FINAL SITE GRADING CONSTRUCTION PLANS
FOR
CREEKSIDE AT LORSON RANCH FILING NO. 1
FINAL GRADING / EROSION CONTROL PLANS

PROJECT:
CREEKSIDE AT LORSON RANCH FILING NO. 1
LORSON BLVD AND CREEK DR.
COLORADO SPRINGS, COLORADO

ENG-SF1913-R1-GEC1-Redlines.pdf Markup Summary

DATE: APRIL 15, 2019
 PROJECT NO. 100.045
 SHEET NUMBER C4.3
 TOTAL SHEETS: 11

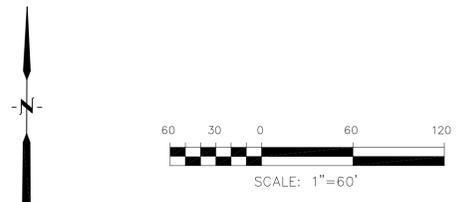
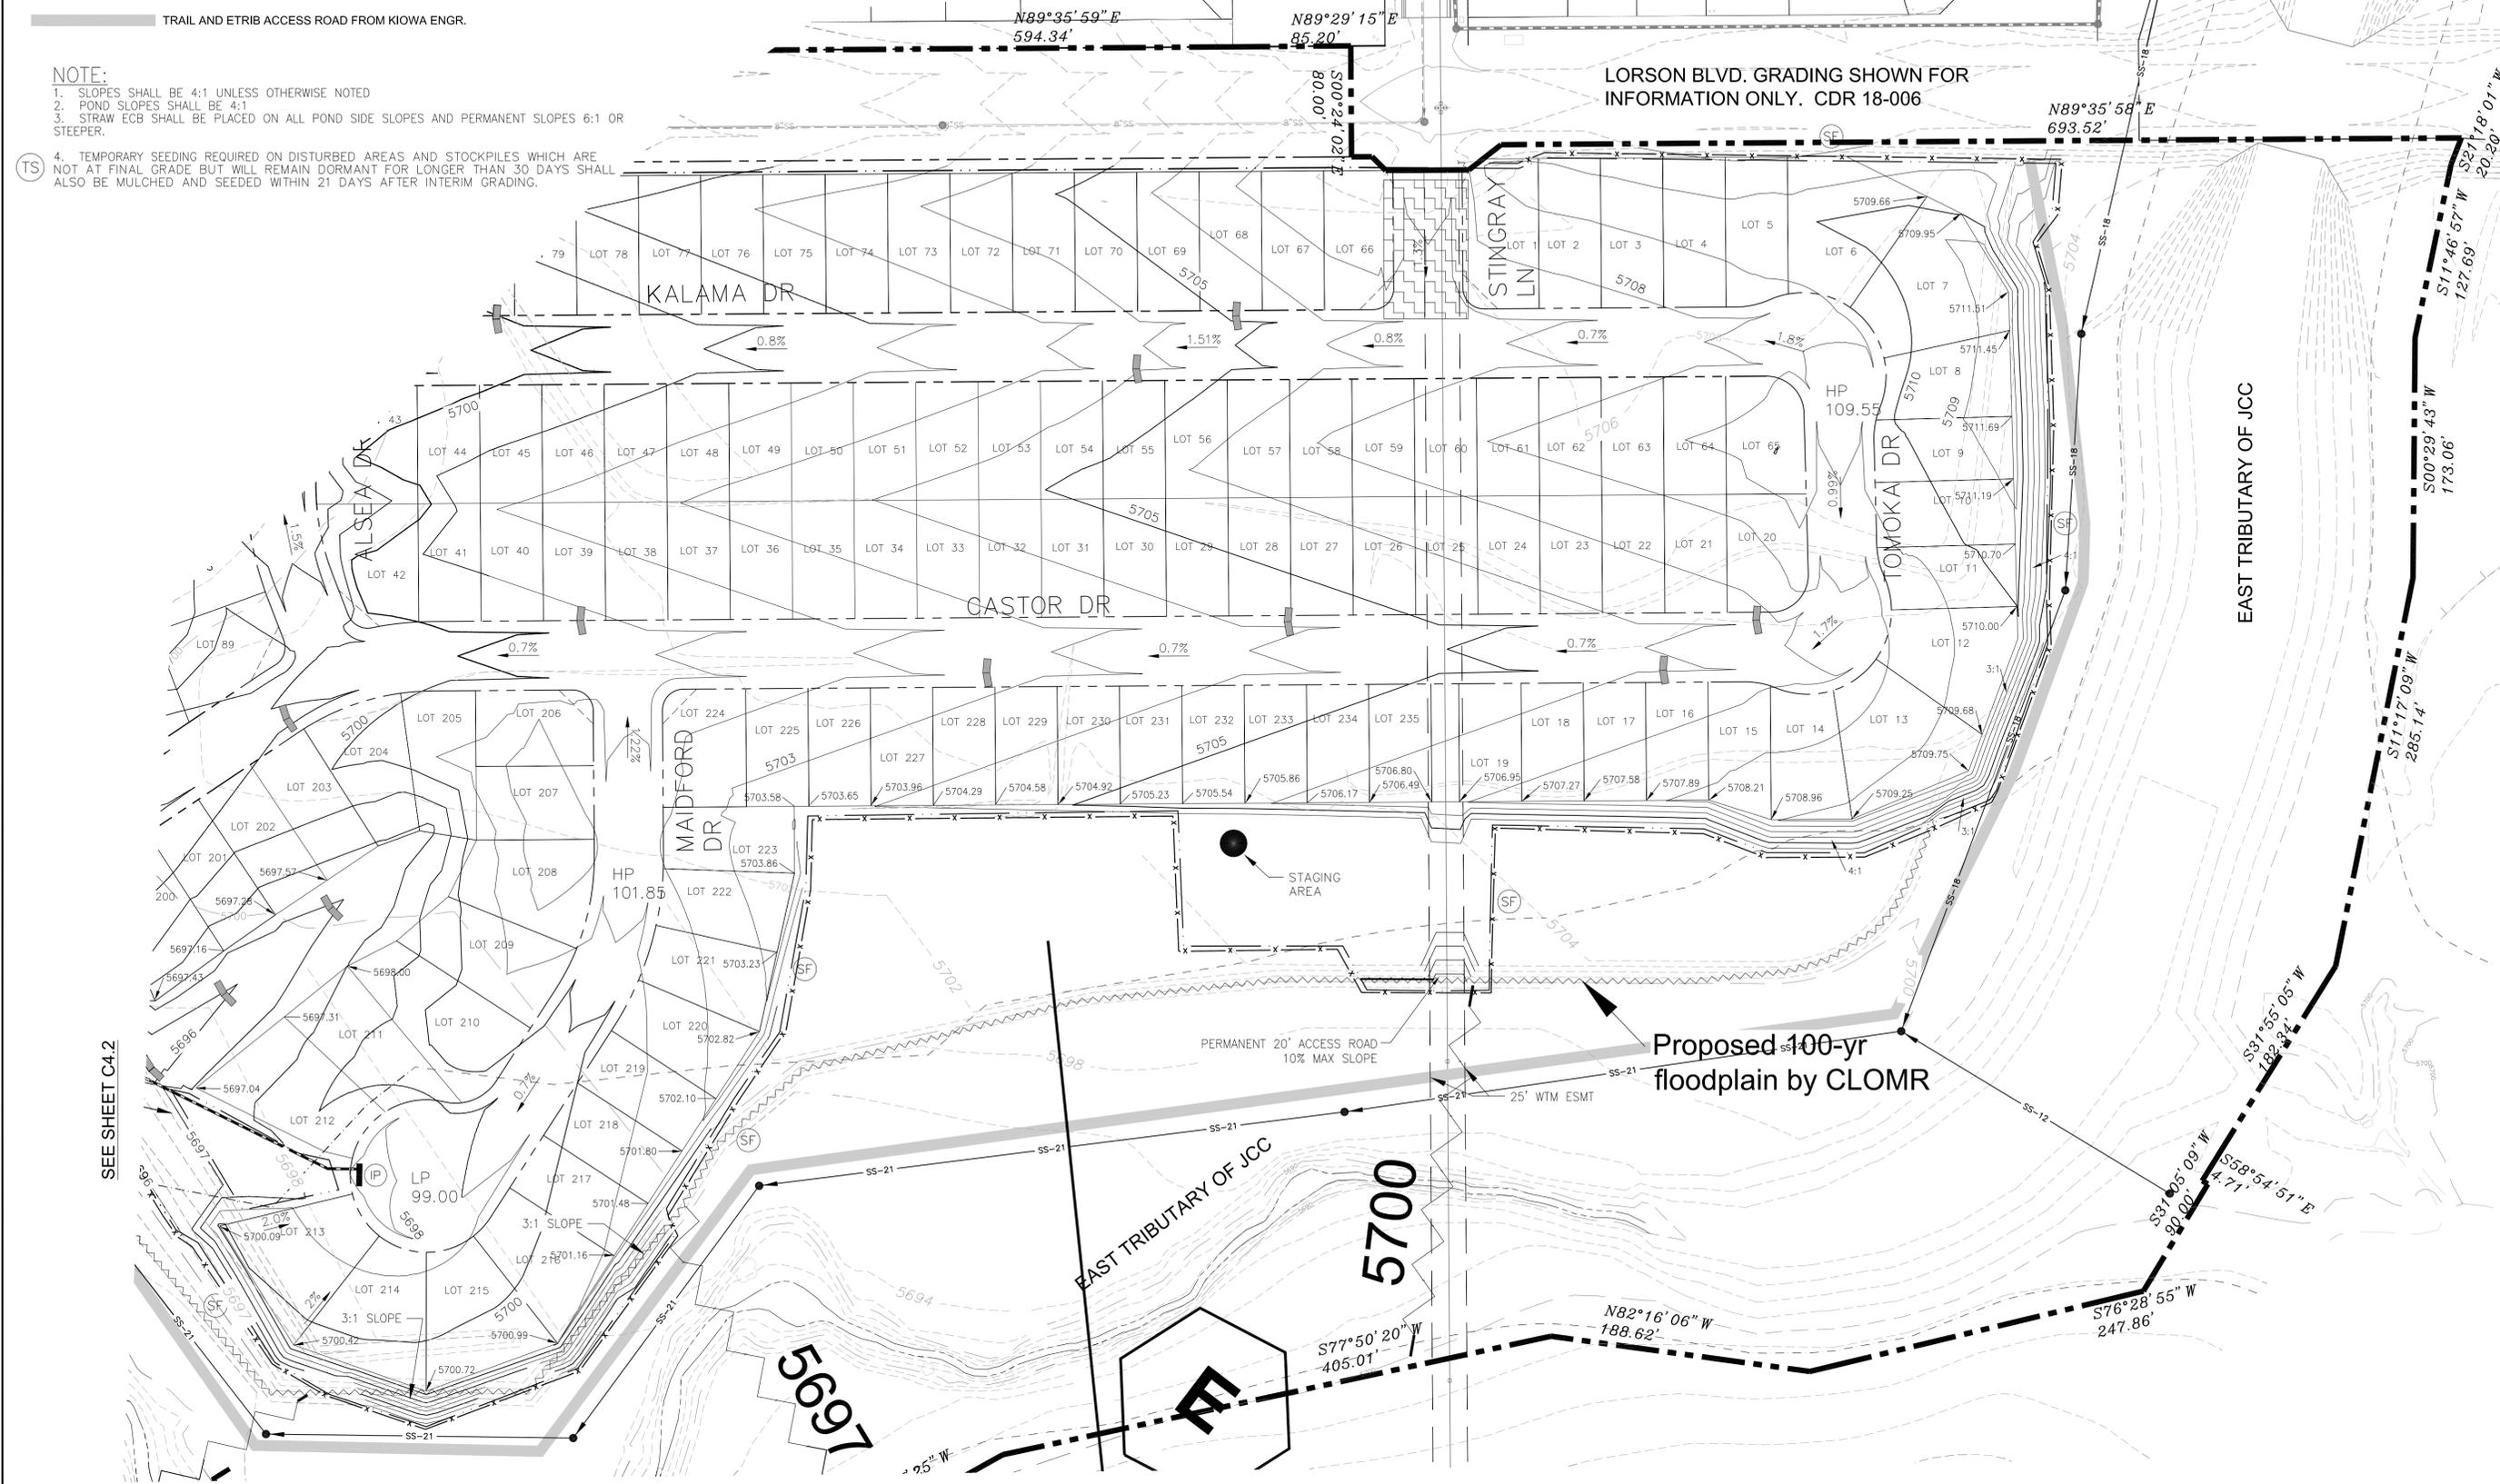
doesn't match the plan?

DATE: APRIL 15, 2019
 PROJECT NO: 100.045
 SHEET NUMBER: **C9.2**
 TOTAL SHEETS: 11

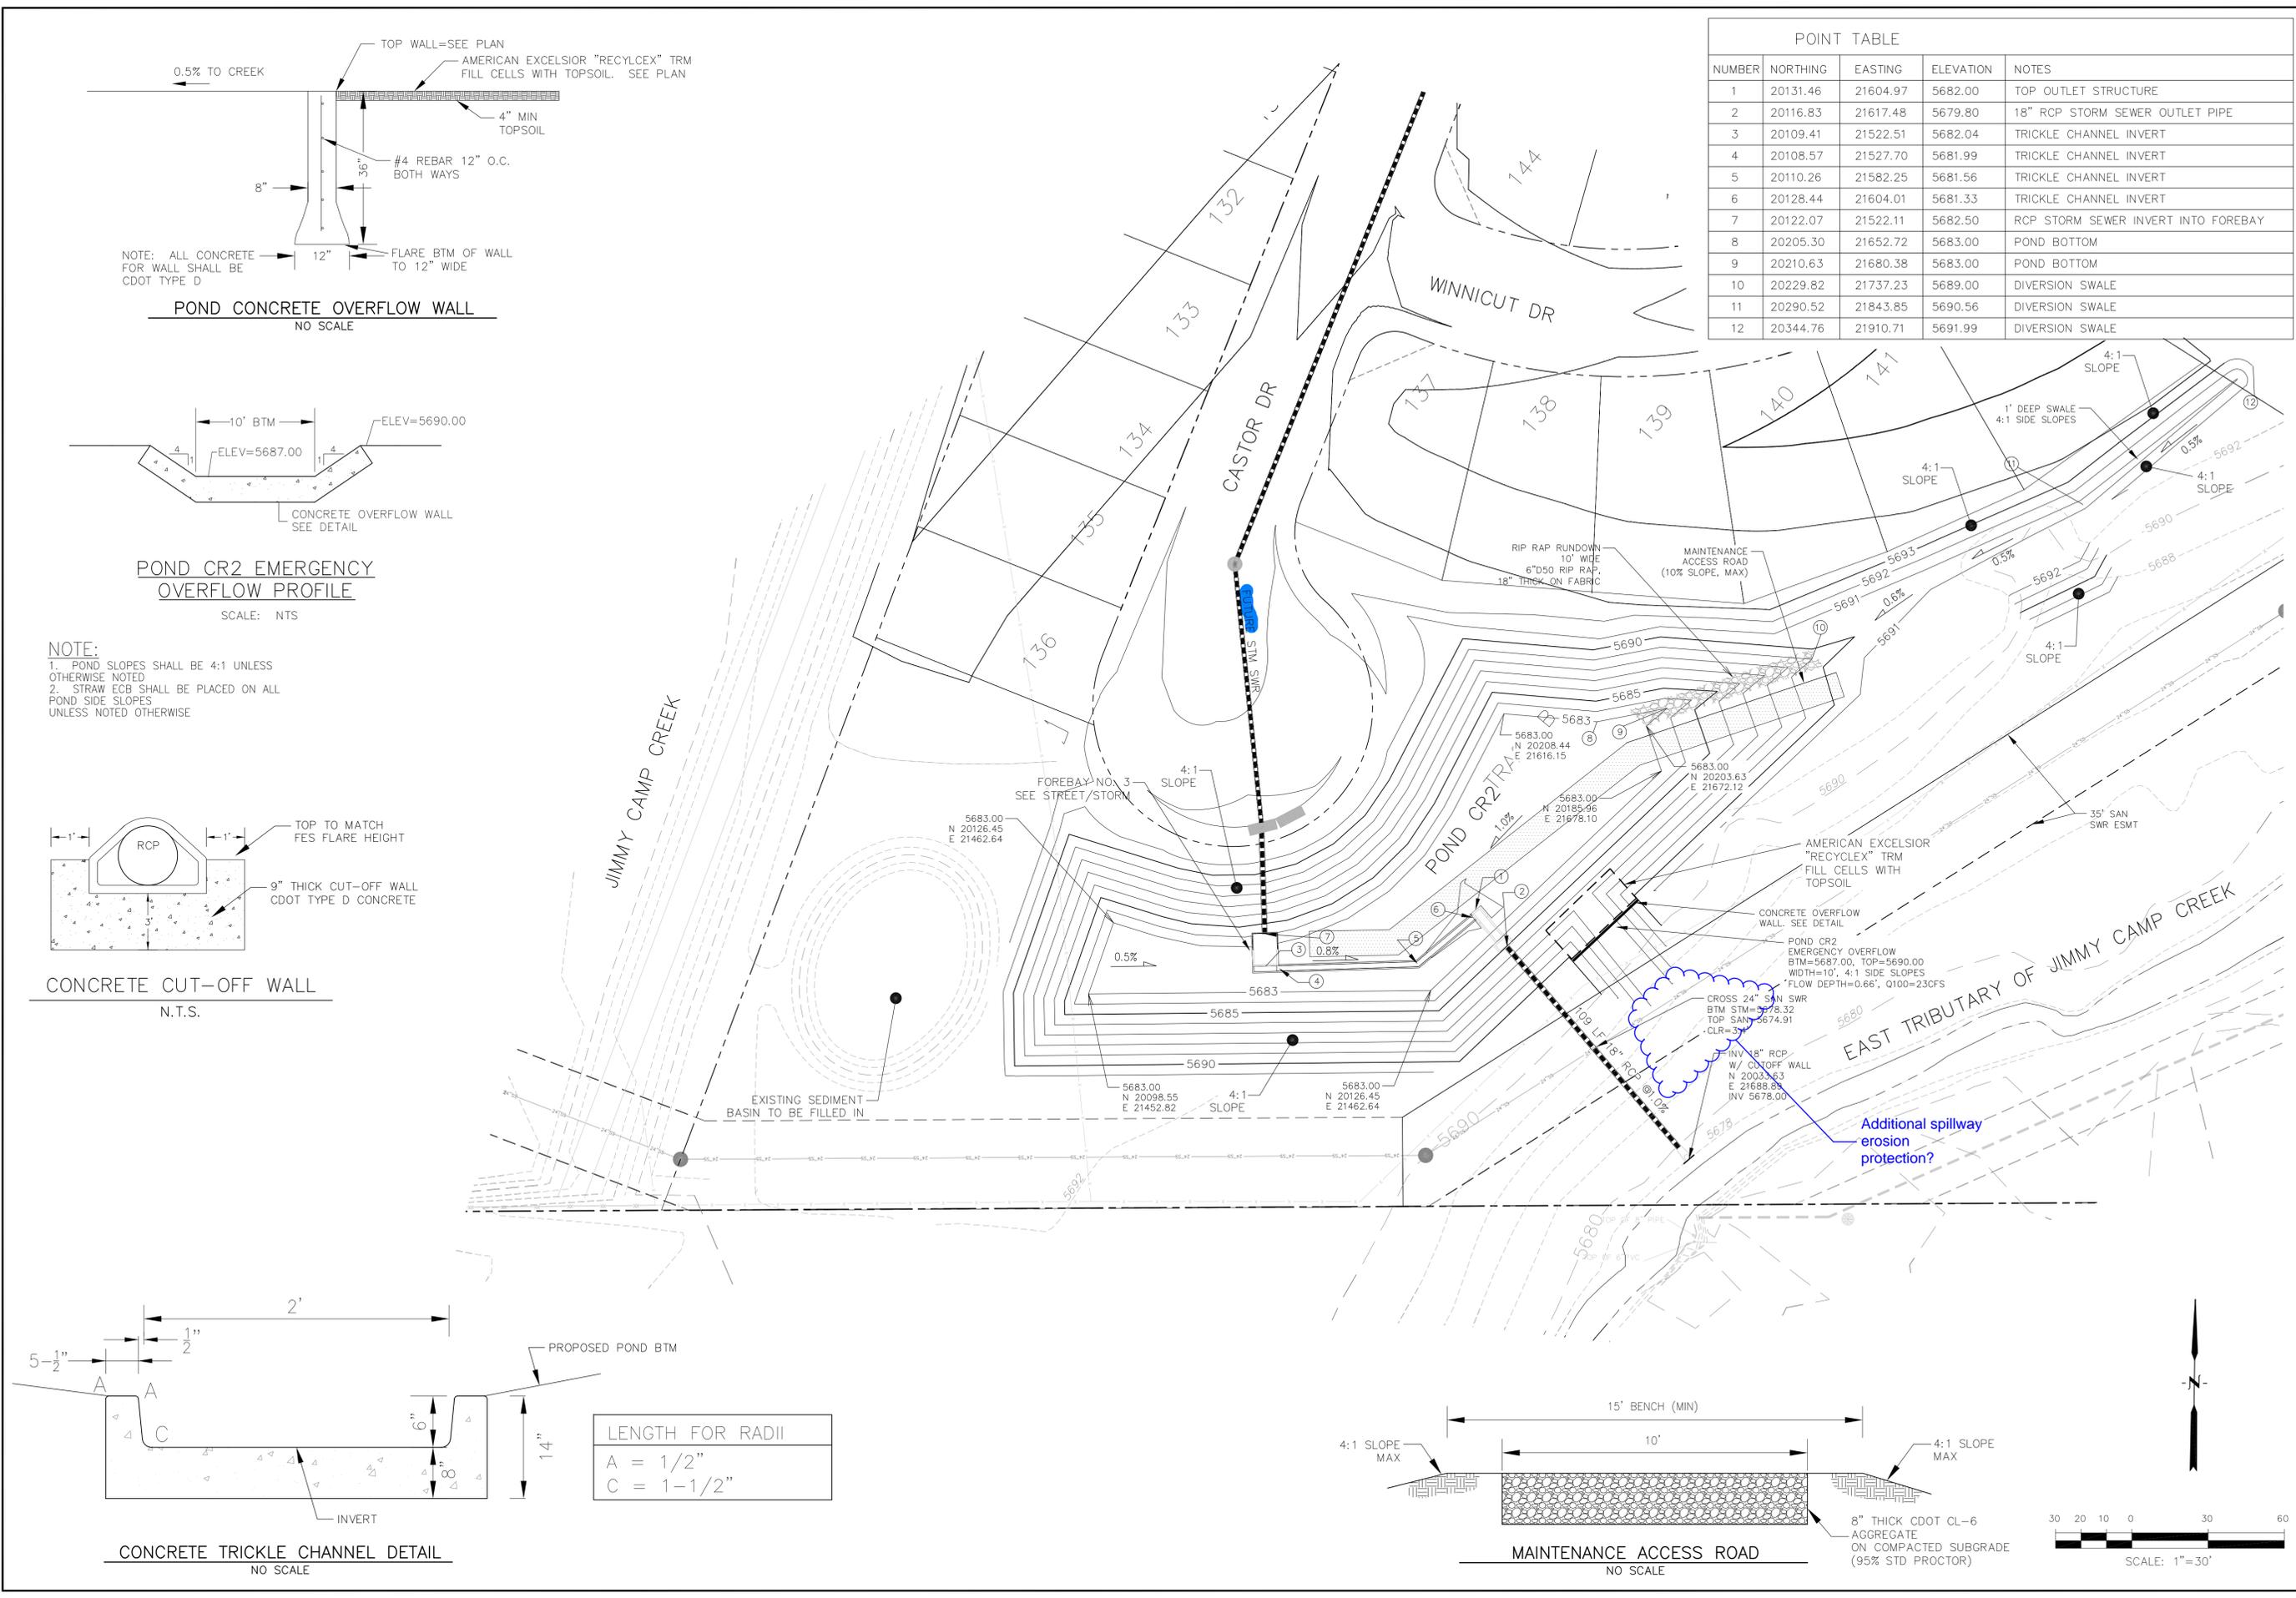
Additional spillway erosion protection?

DATE: _____
PROJECT NO. 100.045
SHEET NUMBER C12.2
TOTAL SHEETS: 11

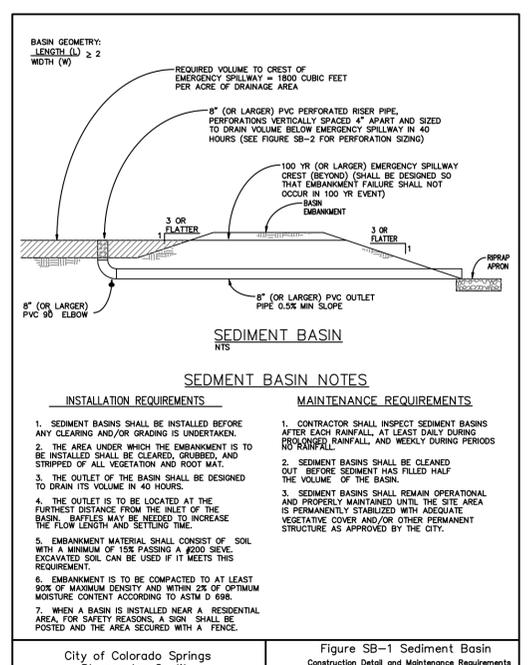
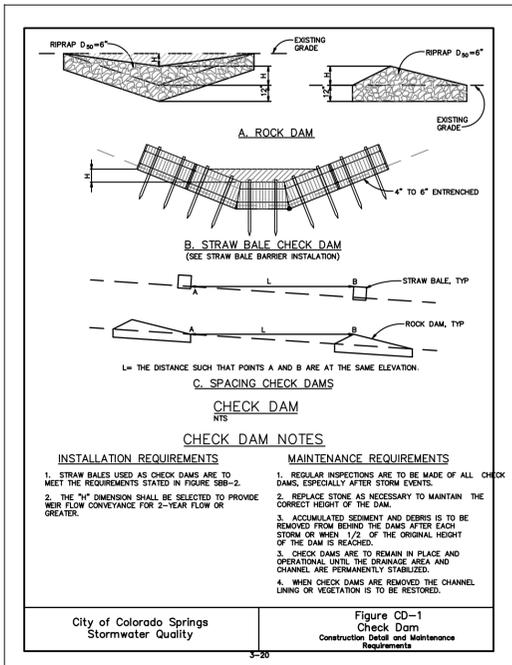
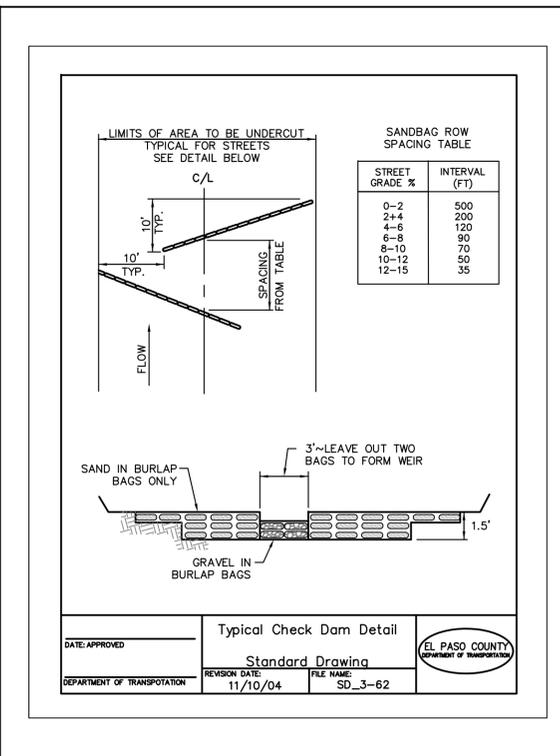
Provide details for interim BMPs including regular inlet protection, ECB, curb socks(?), seeding and mulching details, etc.
